From: WILLIFORD Dennis (AREVA) [Dennis.Williford@areva.com]
Sent: Friday, April 27, 2012 2:51 PM
To: Tesfaye, Getachew
Cc: BENNETT Kathy (AREVA); DELANO Karen (AREVA); ROMINE Judy (AREVA); RYAN Tom (AREVA)
Subject: Response to U.S. EPR Design Certification Application RAI No. 505 (5902,5735,5869,5754,5803,5950,5744), FSAR Ch. 7, Supplement 18
Attachments: RAI 505 Supplement 18 Response US EPR DC.pdf

**QUESTIONS for Instrumentation, Controls and Electrical Engineering 1
(AP1000/EPR Projects) (ICE1)**

Question 07.01-36:**OPEN ITEM**

Figure 7.1-36-1: SAS Master/Standby Configuration

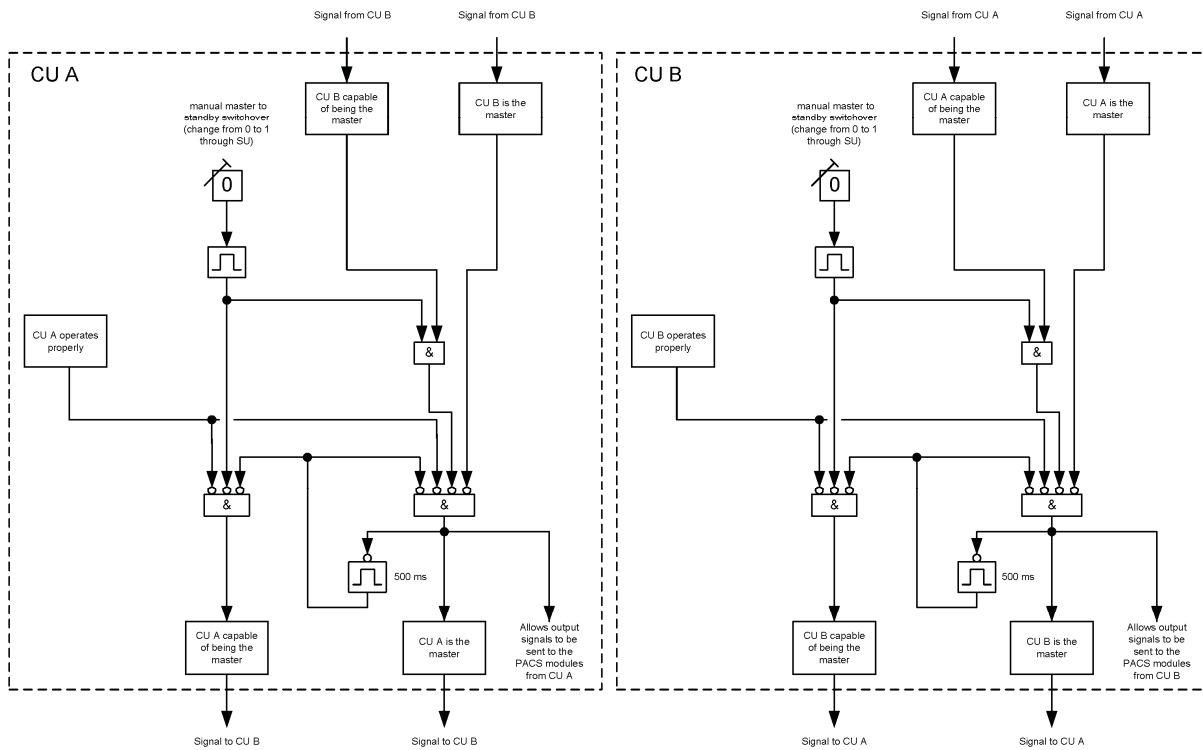
Clarify the new voting scheme for Safety Automation System (SAS) voting logic and how the voting logic is modified in the presence of a single failure.

Upon receiving a start signal from the PS, SAS provides closed-loop controls for specified engineered safety features (ESF) systems to allow the plant reach and maintain safe shutdown conditions. Initially, the design of SAS incorporated a 2nd min / 2nd max selection scheme as part of its divisional logic scheme, which can be seen in U.S. EPR FSAR, Tier 2, Section 7.3, Revision 2. In response to RAI 442, Question 07.03-32, the applicant provided Interim Revision 3 mark-ups of Tier 2, Section 7.3. As shown in Tier 2, Figure 7.3-12, Interim Revision 3 mark-ups, a single sensor voting scheme has replaced the 2nd min / 2nd max function. Given this change to a more conventional voting scheme, the applicant did not provide any design information on the new voting scheme in the FSAR. The applicant also did not provide any information on how SAS voting logic is modified in the presence of a single failure, similar to information provided for the PS in Technical Report ANP-10309P. This information is critical to the staff's evaluation of SAS compliance with IEEE Std. 603-1998, Clause 5.1. The staff requests the applicant provide information in the FSAR concerning the new SAS voting scheme and to also provide information on how SAS voting logic is modified in the presence of single failures, faulty signals and messages, etc.

Figure 07.01-36-1 shows the logic for the master/standby configuration. The master CU controls the process. The outputs to the PACS module of each pair of CUs are OR-gated by hardwiring, but only the master CU is able to send signals to the PACS modules, while the output signals of the standby CU to the PACS modules are blocked. Each CU blocks its own outputs through the software of the CU.

If both CUs do not operate properly (as described above), then both CUs block their outputs to the PACS modules and there will be no master CU designated, until one of the CUs operates properly (as describe above). This results in a loss of a division of SAS and Table 7.1-7 – SAS FMEA Results describes the effects on the plant for a loss of a division of SAS.
